PROPOSAL AND OBJECTIONS FROM 2014 REVIEW

Annex I Haxby and Wigginton Ward**12****Location**

South Lane (off York Road)

Initial Recommendation

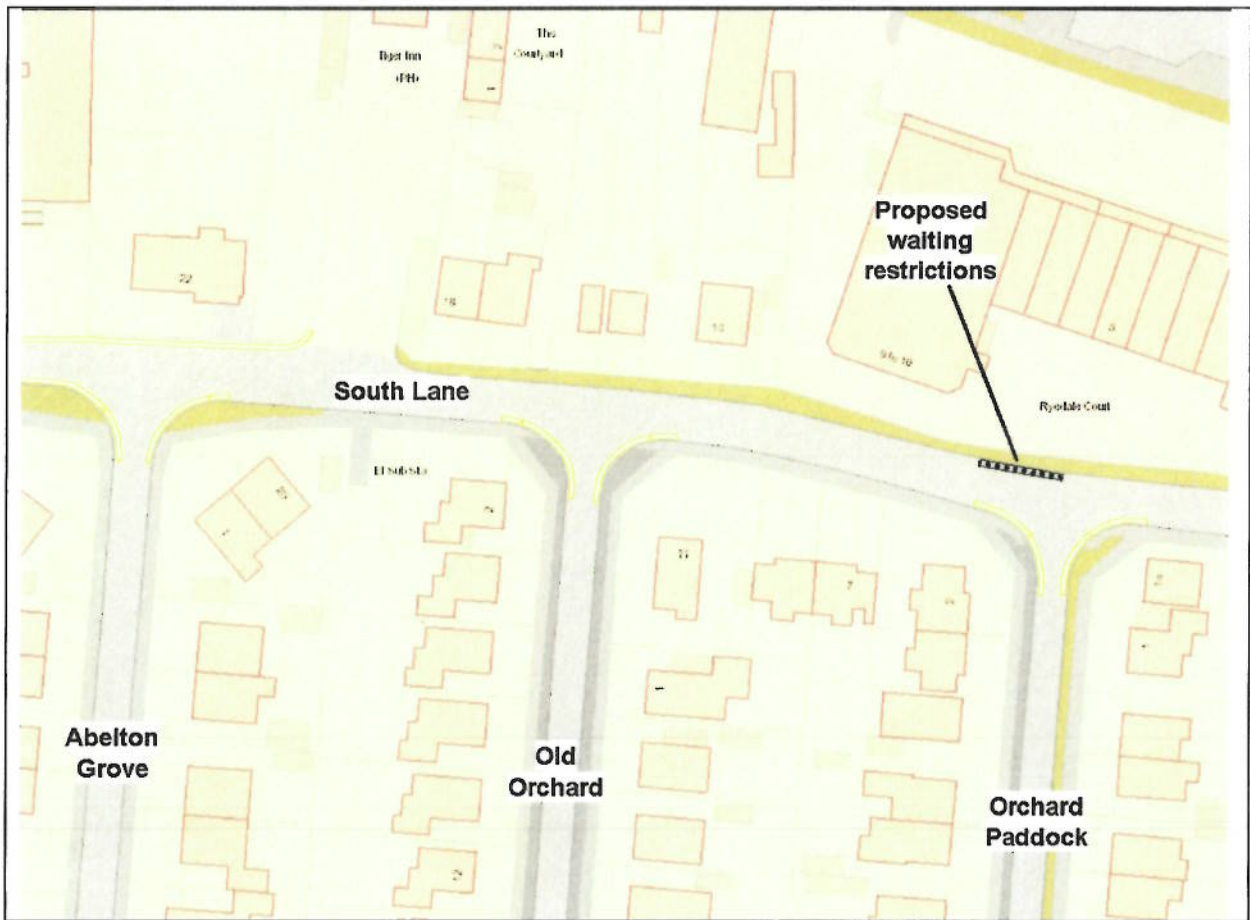
Inconsiderate parking making it difficult to get onto South Lane from roads and driveways on the South side

There were 6 objections received to the proposal and 2 communications in support. The objections are summarised in the points below (many objections included more than one point). The number of objections that included each point is also given.

Objection	Comment
Reduces the amount of parking, as an alternative, parking bays could be used on the south side of South Lane.	The positioning and number of any parking bays in this location could provoke as much opposition as the current proposals.
Displacement of parking into Ableton Grove and possibly other	This is a legitimate concern

locations (3)	
Prevents convenient parking on south side of South Lane (2)	Some residents consider the parking here to be convenient, others consider that it causes inconvenience.
Could make access to drives on the south side of South Lane difficult (2)	There seems to be a genuine difference of opinion between different householders on the south side of South Lane. Some consider the proposals would make access to their drives easier, others think the opposite.
Removing parking will increase vehicle speeds and reduce safety	The proposal will probably have the effect of shifting the parking from the south side of South Lane to the north side with little change in vehicle speeds
Parking on the south side of South Lane is not a problem at the moment	Some residents consider parking here to be a problem, others consider that it isn't.
No road accident record associated with the current parking arrangements	Agreed, but the reason for proposing restrictions was not connected to road accidents

Extend the existing "no waiting at any time" restrictions (double yellow lines) along the South side of South Lane between Ableton Grove and Orchard Paddock. Also install a "no waiting at any time" restriction opposite the North end of Orchard Paddock to protect the right turn into Orchard Paddock.

Recommendation	
Only implement the short length of restrictions on the north side.
